2019 LIFT STATION ELIMINATION NEAR PORTSA
SAWS Solicitation Number: CO-00592
Job No.: 19-2501

ADDENDUM 3
October 04, 2022

NEW LIFT STATION 105
 PROPOSED PLAN AND SECTION VIEWS

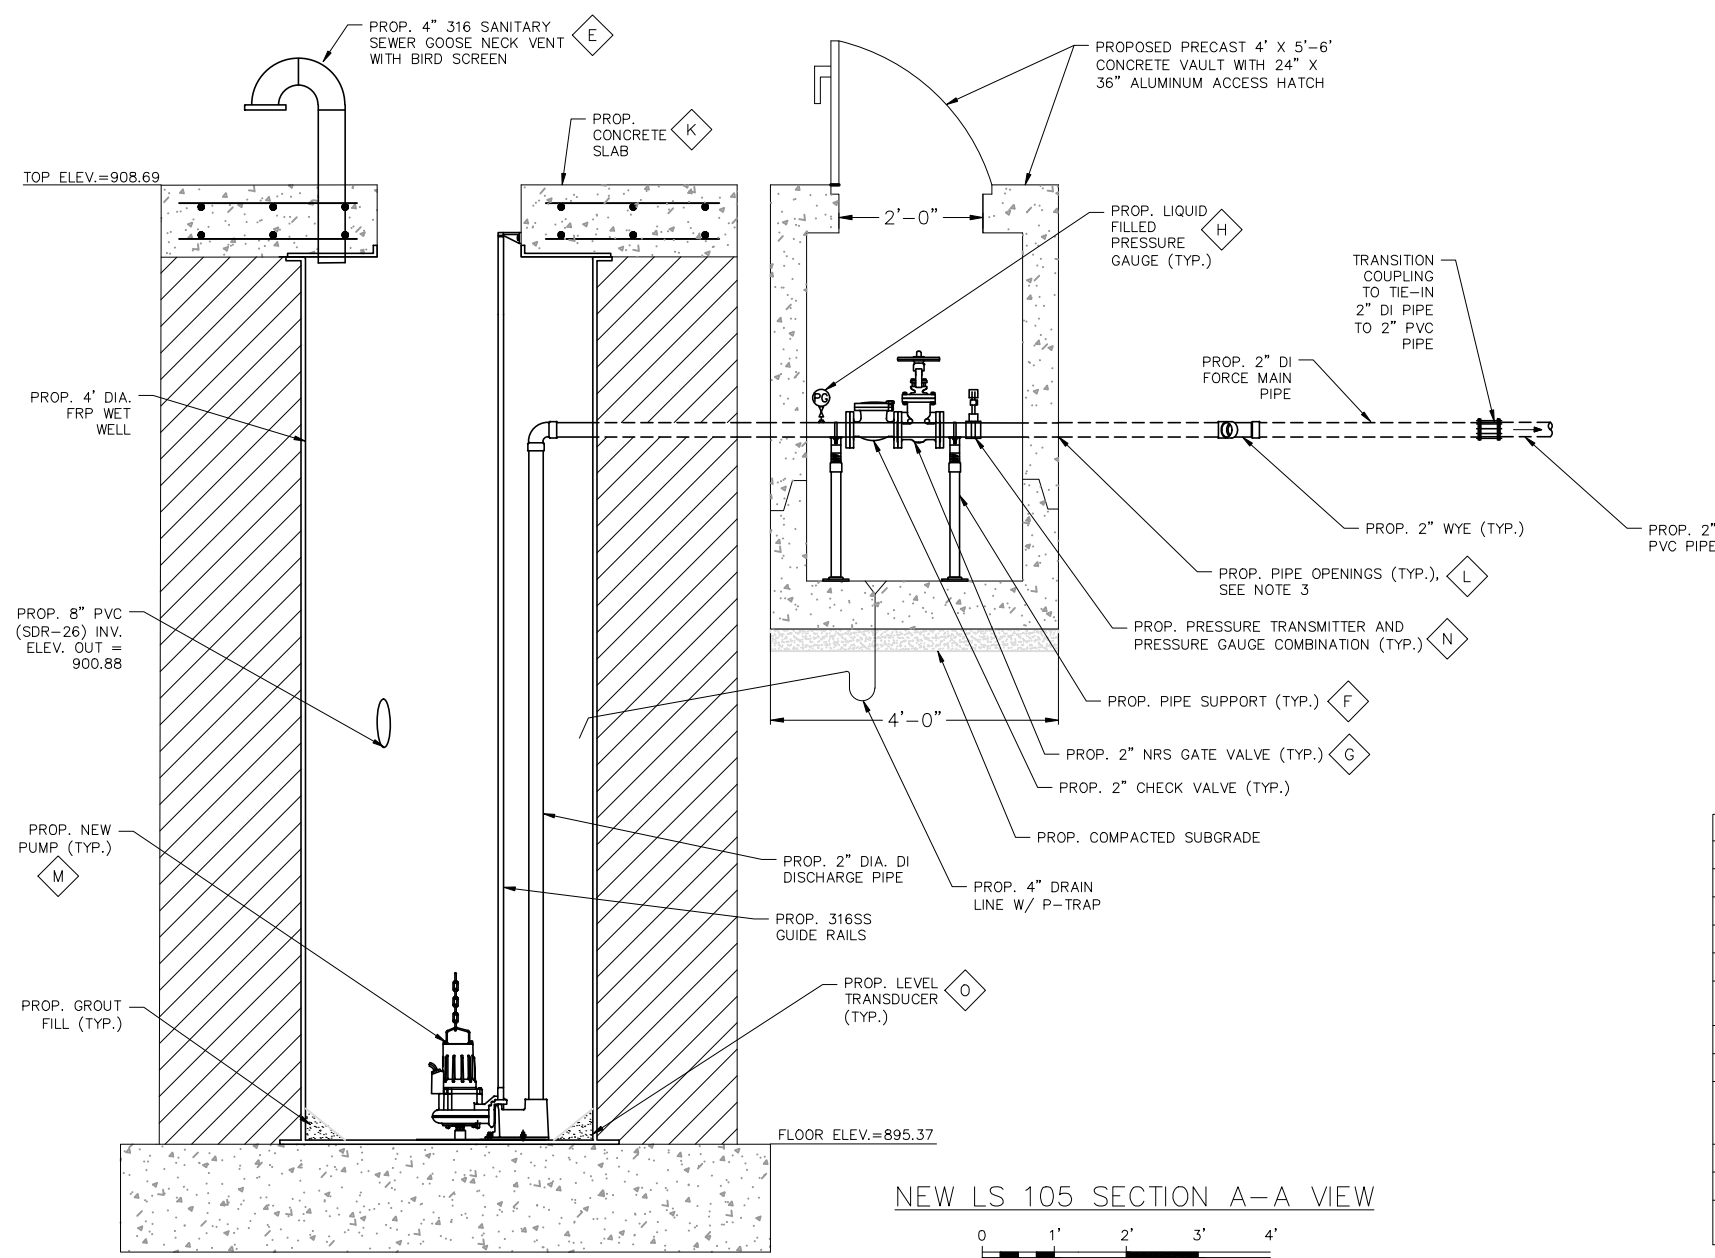
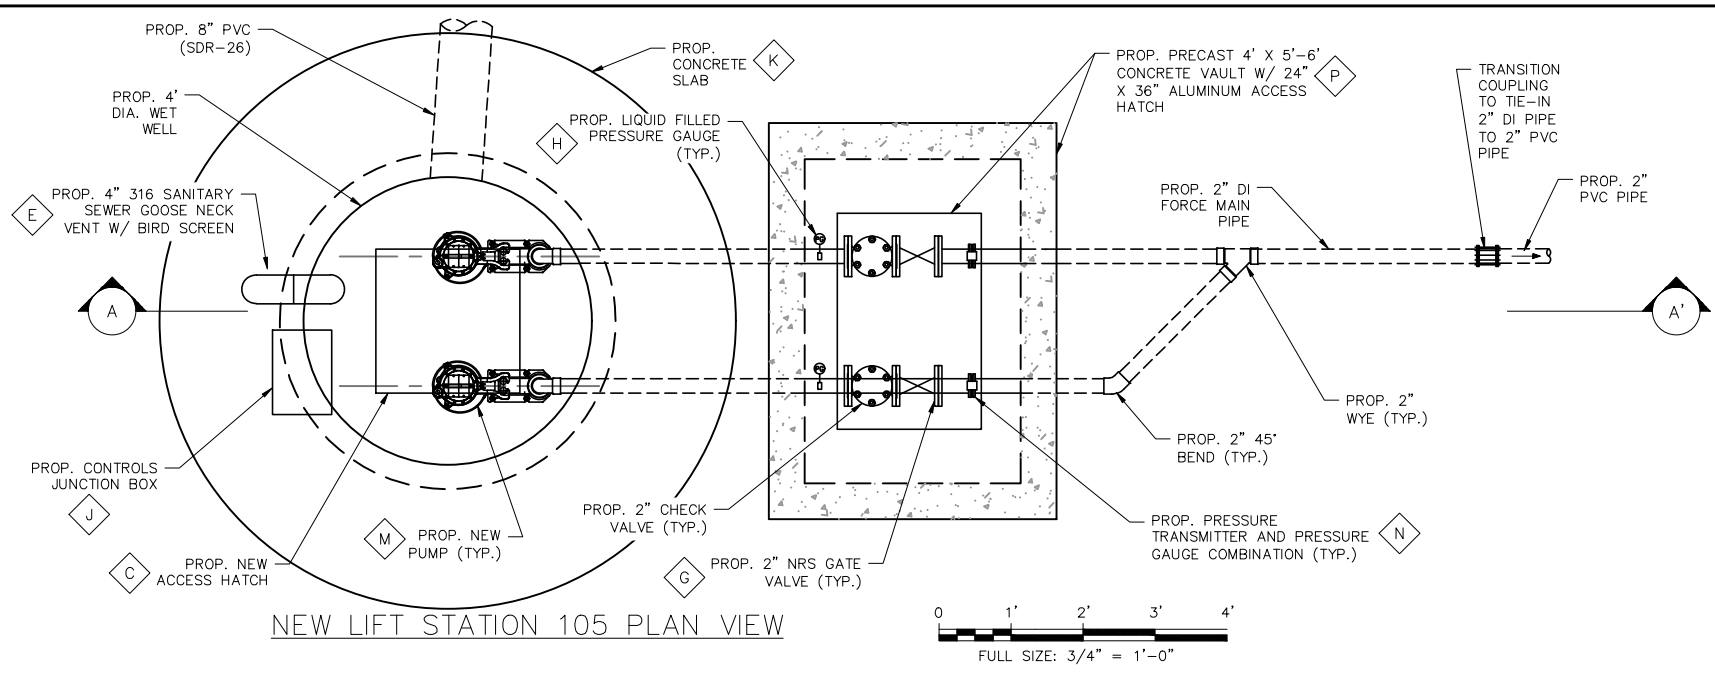
Response:
The plan sheet is correct. Reference Item #4, in Changes to the Specifications section.
- 2. Question:** On Sheet A-06 states that the Approved Flygt pump is a model CP-3045 pump. This is a great pump but it is not designed for domestic wastewater since it is a 2” solids handling pump. A Flygt grinder is the preferred pump to be used in this application and meets TCEQ guidelines for 2” force main using grinder pumps not non-clogs.

Response:
The Contractor shall provide a grinder pump as per specification section 11312 – Wet Pit submersible Grinder Pumps for wastewater. Reference Item #1 and Item #2, in Changes to Plans and Item 4, in Changes to Specifications section in this Addendum.

- b. Sheet A-06 (17 of 99) New Lift Station 105 Proposed Plan and Section Views – dated 10/04/2022
- c. Sheet E-07 (89 of 99) LS 326 Proposed Gravity Line – dated 10/04/2022

LS 105 PUMP INFORMATION	
MANUFACTURER	XYLEM FLYGT CORP. OR APPROVED EQUAL
MODEL	M3085 HT3
HORSEPOWER (HP)	4
DISCHARGE DIA. (IN)	2
IMPELLER DIA. (MM)	150 MM
FLOW (GPM)	30
TOTAL HEAD (FT)	31
